Groundwater Application Review Summary Form

Application # G- 19236

GW Reviewer Phillip I. Marcy Date Review Completed: 06/17/2024

SUBJECT: Scenic Waterway Interference Evaluation

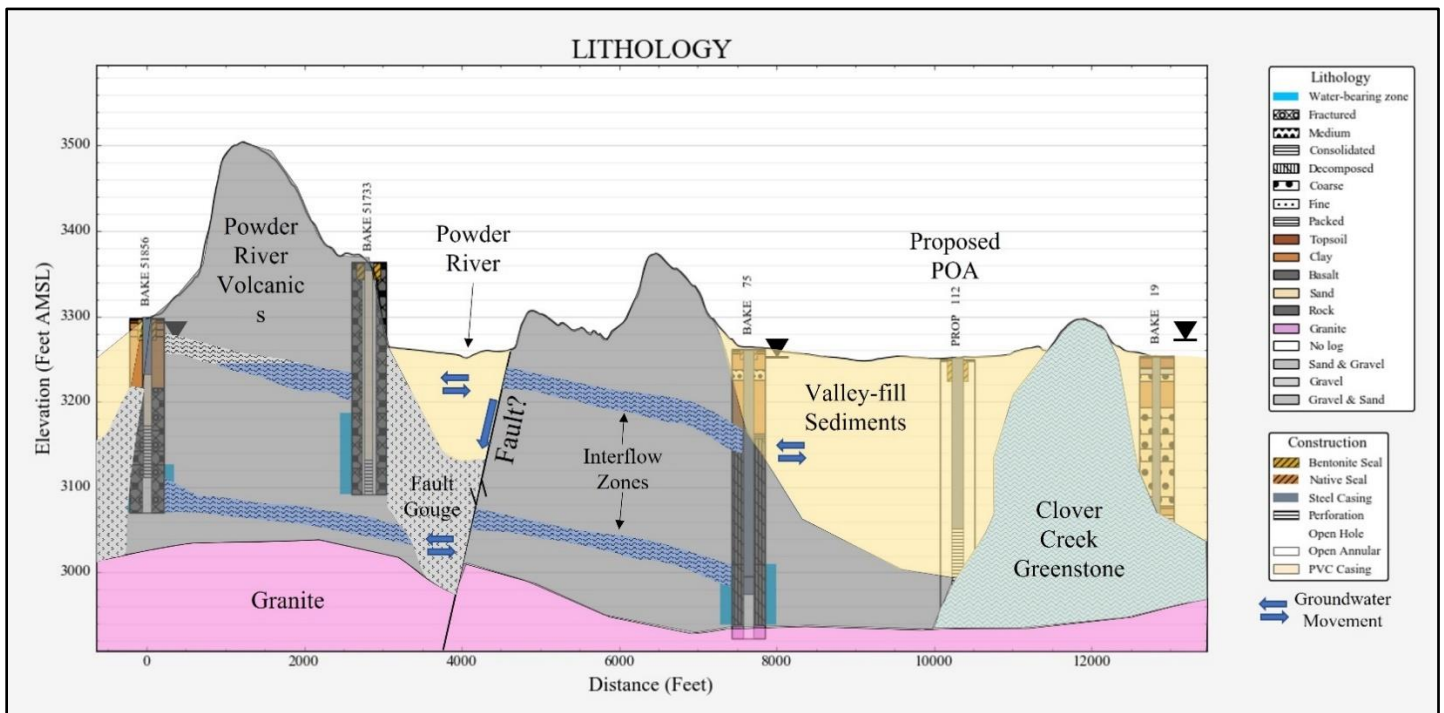
Idealized cross-section for the area of proposed development depicts our conceptual model of the relationship between mapped lithologies (Brooks, 1976) and those reported on driller’s logs. Erosional remnants of Powder River Volcanics in places directly overlay granite, while in other locations is likely that “rock” or “basalt” are used interchangeably and may indicate either Miocene volcanic or Mesozoic metasedimentary rock (Clover Creek Greenstone). Interflow zones in volcanic flow rocks are relatively permeable and produce moderately high yields to nearby wells, while dense flow interiors have very low permeability. In cases where volcanic sequences are laterally extensive and the sequence remains intact, aquifers housed in interflow zones can display high degrees of isolation from surface water and adjacent aquifers, as evidenced by water level trends that diverge from both adjacent aquifers and seasonal patterns of surface recharge. Considering the available evidence, interflow zones within the volcanic sequence here are likely highly dissected by erosion and offset by faulting, in turn creating efficient pathways for groundwater to move to and from these aquifer zones and adjacent unconfined surficial aquifers.

Water-Level Measurements in Nearby Wells

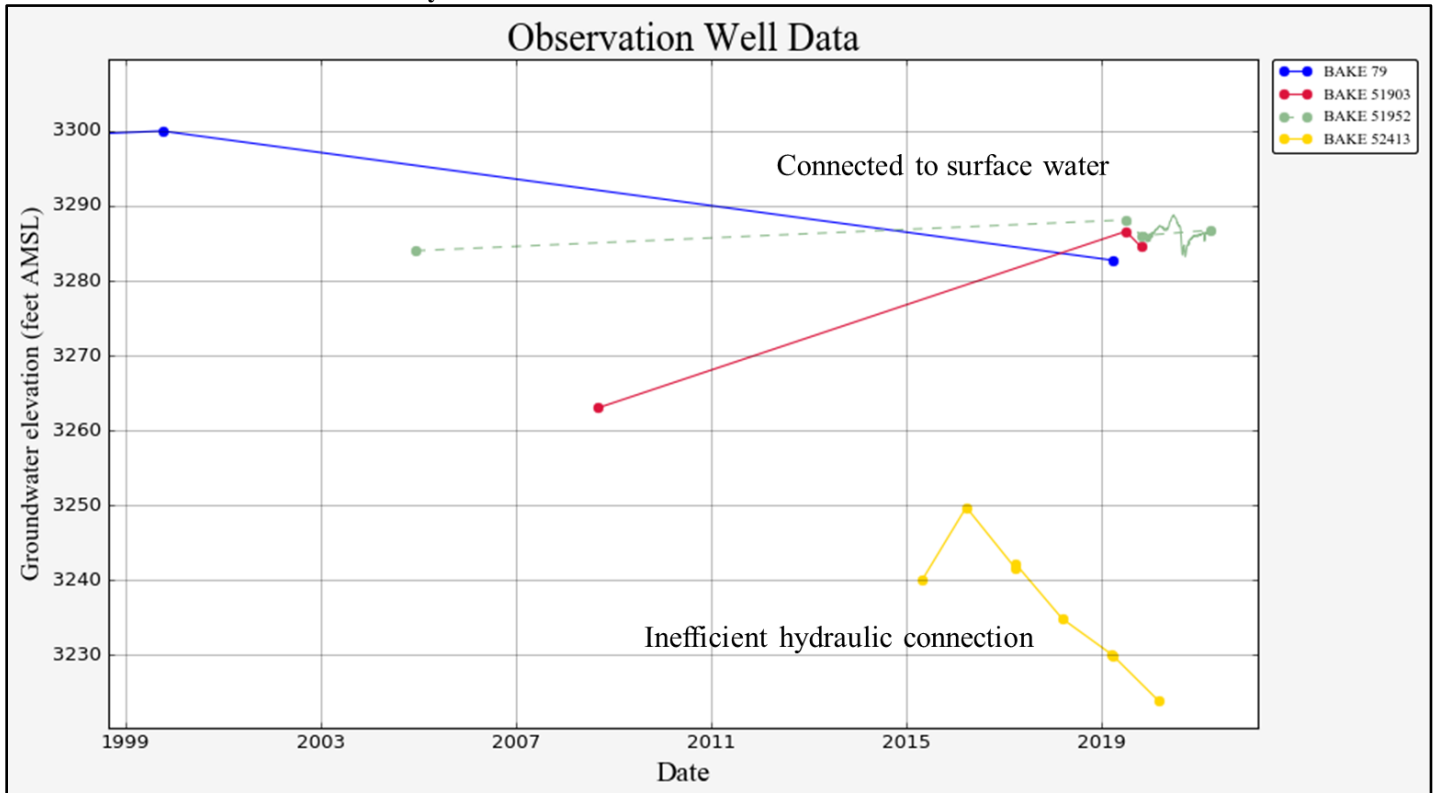
Recent water level data are sparse for the area of interest, but two distinct trends illustrate the impact of hydraulic connection to surface water in addition to providing evidence that the degree of connectivity is largely controlled by local geologic structure. The three wells with water levels between 3,280 and 3,290 feet AMSL have remained fairly stable over the period of record and display seasonal changes in the continuous record of BAKE 51952 (below). Like BAKE 51952, BAKE 52413 is also constructed to produce from fractured zones within granite but displays much different behavior. The year-upon-year declines reported in this well illustrate limited recharge to this aquifer, thus lack of hydraulic connection to surface water. The difference between these two situations is likely the degree to which fractures in bedrock are connected to adjacent aquifer materials in the adjacent sedimentary sequence.
